MONTGOMERY COUNTY DEPARTMENT OF PARK AND PLANNING

MEMORANDUM

Preliminary Plan Review

PROJECT NAME: Leawood

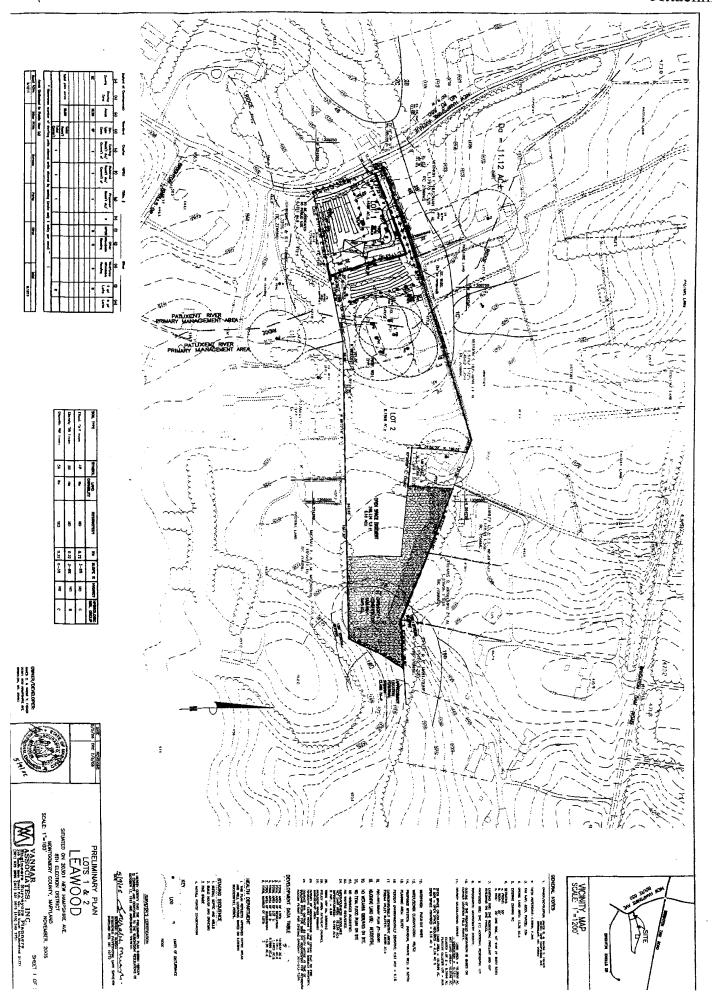
Access to the proposed lots will be to New Hampshire Avenue via an existing, shared driveway. The lots will be served by private wells and standard trench septic systems.

In addition, the final forest conservation plan is required to include a final tree protection plan for the large trees that are located along the existing driveway. Depending on the final configuration of the proposed driveway to serve the house on Lot 1, one or more of the large trees may need to be removed. Staff had suggested that the new driveway for Lot 1 be located

about 300 feet from New Hampshire Avenue in order to avoid all disturbance within the critical root zones of the large trees. However, the applicant has indicated that if the new driveway is over 150 feet from New Hampshire Avenue, Fire and Rescue would require the existing portion of the common driveway to be reconstructed with a wider cross section that would likely result in the loss of all trees. Therefore, staff supports the location of the new driveway as proposed, and will incorporate necessary tree protection into the final tree save plan.

- ii. Planting plan to use a minimum of 1" caliper native trees.
 - iii. Final tree protection plan to show proposed final driveway location, grading, and limits of disturbance for proposed Lot 1. The tree protection plan will also identify which trees along the common driveway may be protected and which trees must be removed.
